STAFF RECOMMENDATION: Approval with Conditions. A draft Staff Report for the Project Plan and Site Plan will be available on March 25, 2003.

The proposed Amendments of the Friendship Place Project Plan and Site Plan maintain the approved development square footage total while rearranging and resizing the uses in the mix. The applicant has also filed a Preliminary Plan Amendment application 1-99030A that will be reviewed concurrently with the Project and Site Plans and will be heard by the Planning Board on the same day.

STAFF RECOMMENDATION

The staff recommends approval of **Project Plan Amendment #9-99001B** and **Site Plan Amendment 8-01010A** for 305,000 sf Office Space, 265,000 sf Retail Space, 20,500 sf Community Center (Non-FAR), 50,000 sf Grocery Store (40,000 sf Non-FAR), 433 Residential Units, and 1,749 Parking Spaces, subject to the following:

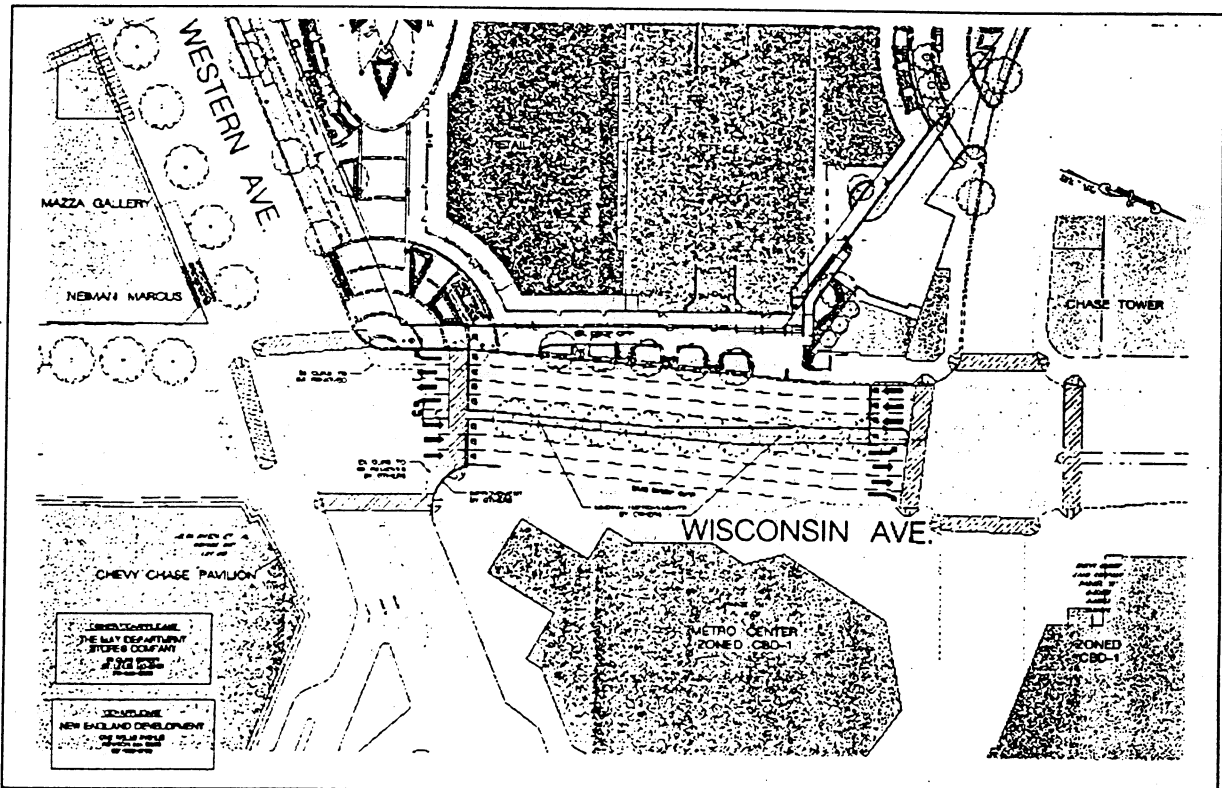
V. The Public Amenity Space at the Major Public Park

STAFF POSITION: The design of the park and the surrounding public space is a key element of the Sector Plan. The quality of the public space, pedestrian safety and potential community activities should not be compromised.

Fig. 16 Public Park proposed amendment 2003

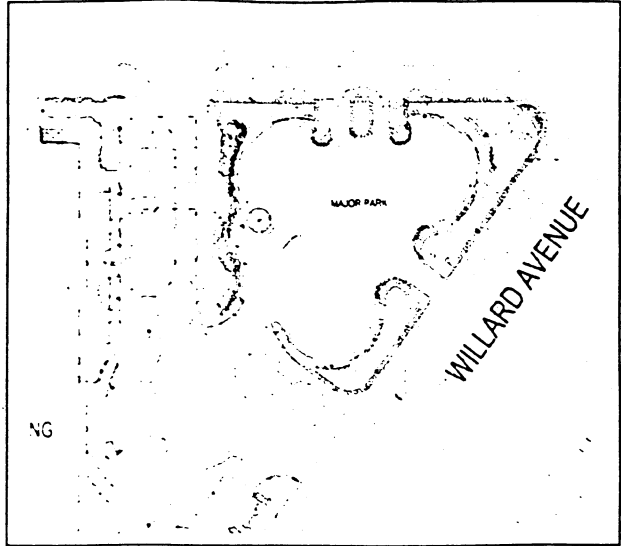
The design for public space that forms the periphery of the Major Public Park has been revised for the amendment proposals. The design changes include the enlargement of private outdoor terraces, widening of the entry drive, addition of a parking lane, reduction of sidewalk width, and the shift of the building footprint, toward the park creates. The landscaping at the park edge has been revised to create a continuous wall of trees and hedge that isolate the park from the surrounding space that was originally programmed to support public venues such as concerts, fairs, and art shows. These subtractive design measures ultimately result in the erosion of the quality and quantity of this public space and compromise of the public safety and enjoyment of the Sector Plan park. Staff has included Site Plan conditions that address the design of the park edge (Conditions (10(g)(i-vii)).

- ii. Provide seating in pre-cast concrete: label seating capacity.
- g. Major Public Park
 - i. Convert the private terraces facing the Major Public Park into public open space and landscaping amenities;

- iv. Reduce the width of the drive aisle at the turn-about to 20 feet;
 - v. Provide a cross walk near the turn-about for safe pedestrian passage;
 - vi. Match the tree planting beds on the south side of the drive aisle with those on the north side;

- ii. Create visual and pedestrian connections between the park and the north façade of the housing as per the previously approved site plan to strengthen the public character of the the amenity space; provide substantial landscaping at the front of the Housing for the planting beds (Condition 10(g)(2)); plant all shade trees lining the entrance drive in landscape strip (no tree boxes);

- iii. Provide shade tree in the turn-about island and on the south side of the turn-about.

Fig. 19 Community Center Elevation showing entrance and steps connecting steps to Friendship Boulevard

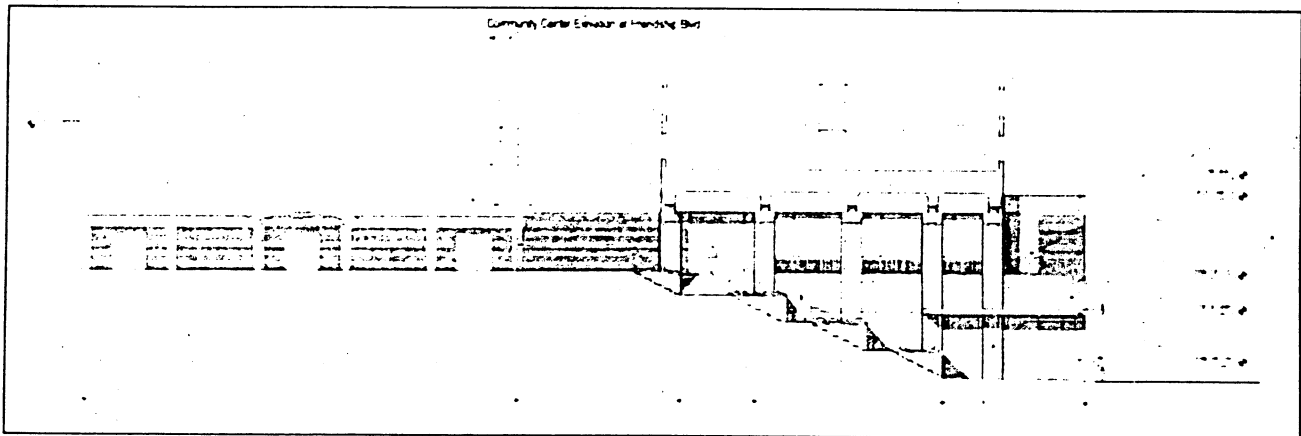
- c. Provide seating near the Community Center entrance on Friendship Boulevard;
- d. Integrate landscaping and public art into the Friendship Boulevard stair design; provide special paving or arcade lighting from the North Courtyard to the Community Center entrance;

- e. Provide landscaping at garage entrance near the stair retaining wall on Friendship Boulevard;
- f. Increase the width of the pedestrian passage from the public elevator to the Community Center entrance;
